**SERVICE**  
**597- AND 598-TYPE PANELS**  
**IDENTIFICATION, INSTALLATION, AND CONNECTIONS**  
**1A2 KEY TELEPHONE SYSTEM**

**1.001** This addendum supplements Section 518-215-417, Issue 7. Place this pink sheet ahead of Page 1 of the section.

Fig. 48—Connections for 448A KTU (Variable Delay Timer Circuit) in 598-Type Panel (Sheet 2 of 2)

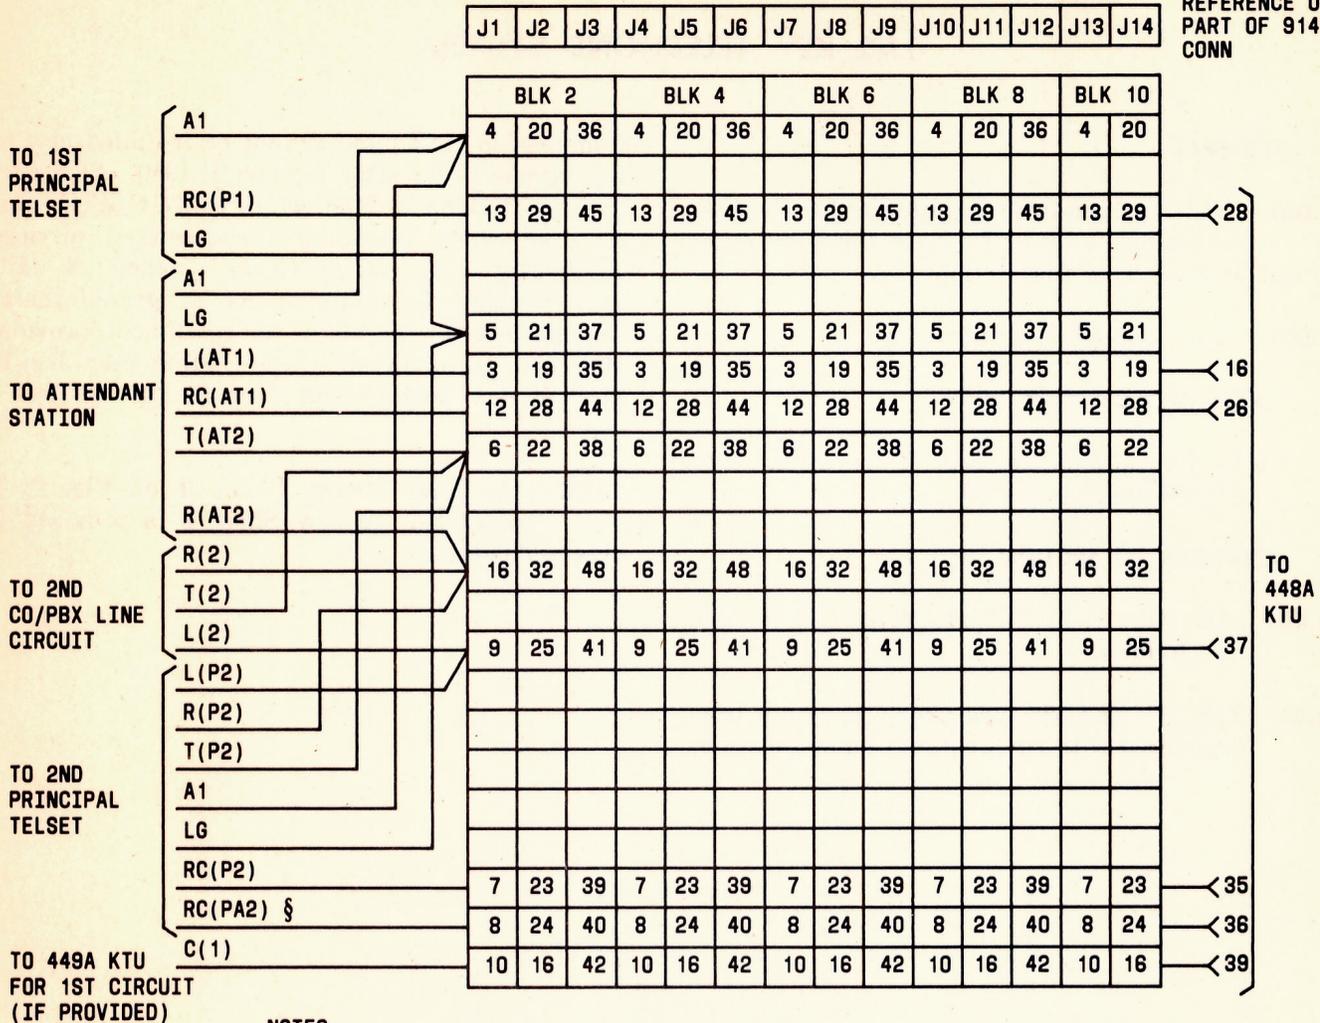
- Revise paragraph 1.04
- Revise options on Fig. 48 to agree with SD-69590-01, Issue 3D

**2.002** On Page 57/58, Sheet 2 of Fig. 48 is obsolete. A new Sheet 2 is provided in this addendum.

OPTION STRAPPING ON 448A KTU OPTION BLOCK

FEATURES		OPTION	STRAP TERMINALS	
			1ST CKT	2ND CKT
AUDIBLE SIGNALS	INTERRUPTED RING	S, J	8 TO 7	3 TO 5
	STEADY RING	T	8 TO 6	3 TO 4
	STEADY BUZZER	N	8 TO 10	3 TO 1
